SERVICE INFORMATION

STANDARD AND TRIUMPH VEHICLES

No.	SPORTS/2/E	JUMPING OUT OF SECOND GEAR	Date	APRIL 1954
------------	------------	----------------------------	-------------	------------

1 ILLUSTRATION

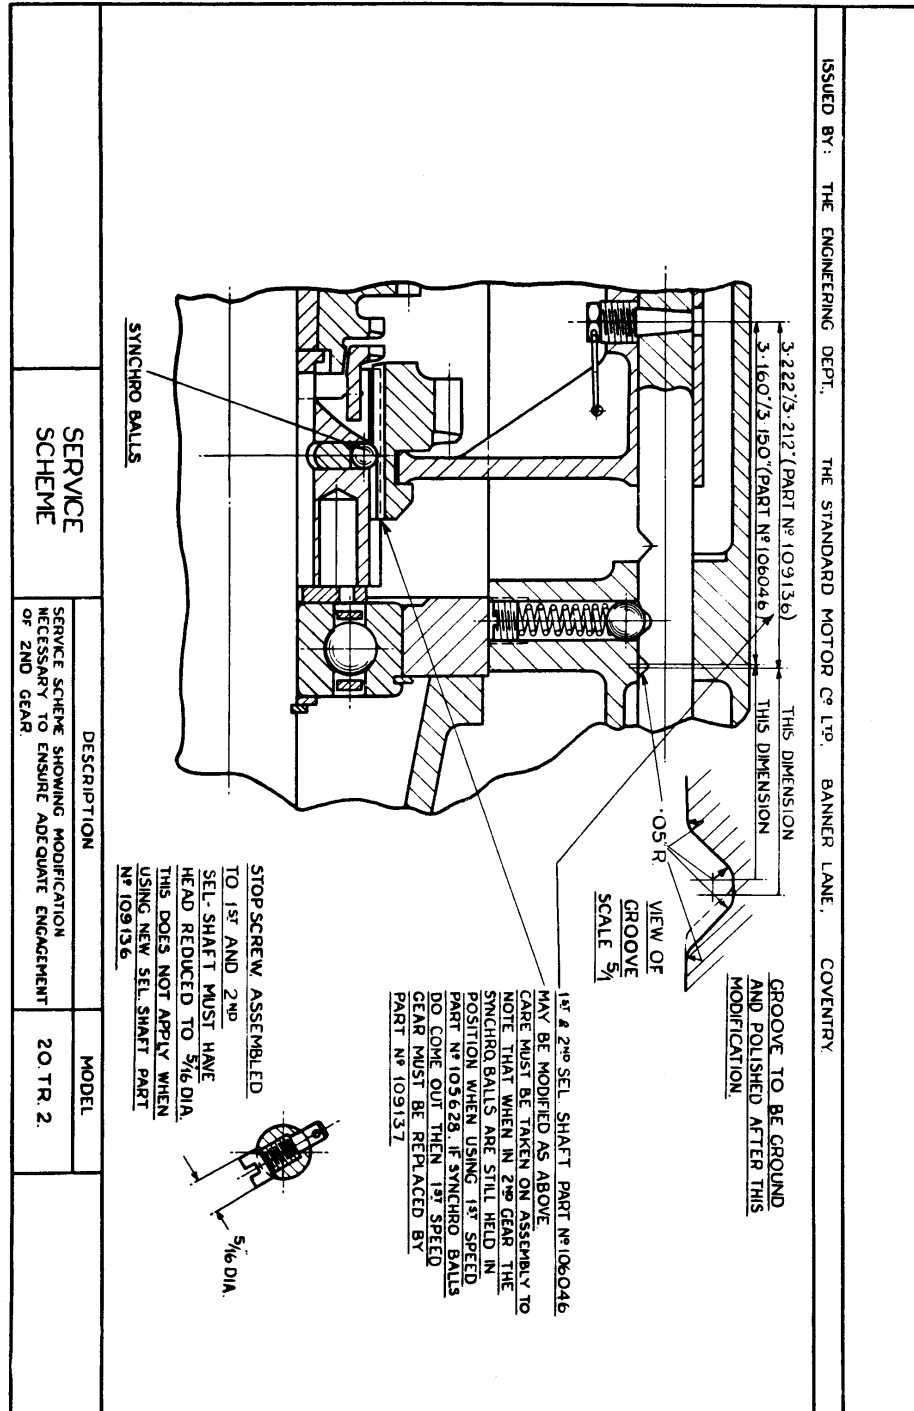
On earlier gearboxes it was possible, with certain combinations of limits, to have inadequate engagement on the flank of the dog teeth. This condition, apart from the crushing and bruising, owing to the small bearing area which permitted overdrive load to be carried on all dog teeth, allowed the gear to slip out when subjected to any appreciable over-run load.

Increased depth of gear engagement has been obtained by a modified selector shaft, Part No. 109136, with an altered locating groove, but the original selector rod, Part No. 106046, may be modified as shown in the illustration.

The extra movement of the 1st. mainshaft gear, Part No. 105628, to engage more fully the “Second” gear dog teeth, will reduce the shrouding of the interlock plungers and synchro mesh balls. The effective length of the “First” gear has been increased in a modified gear under Part No. 109137 to allow for this movement.

It will sometimes be possible to use the original “First” gear with the new selector shaft, if the combination of limits in the box is favourable, but if doubt exists as to the possibility of plungers or balls becoming displaced, the now lengthened gear should be fitted.

The “Second” speed mainshaft gears will generally have to be replaced owing to the dog teeth having been previously damaged by inadequate meshing.
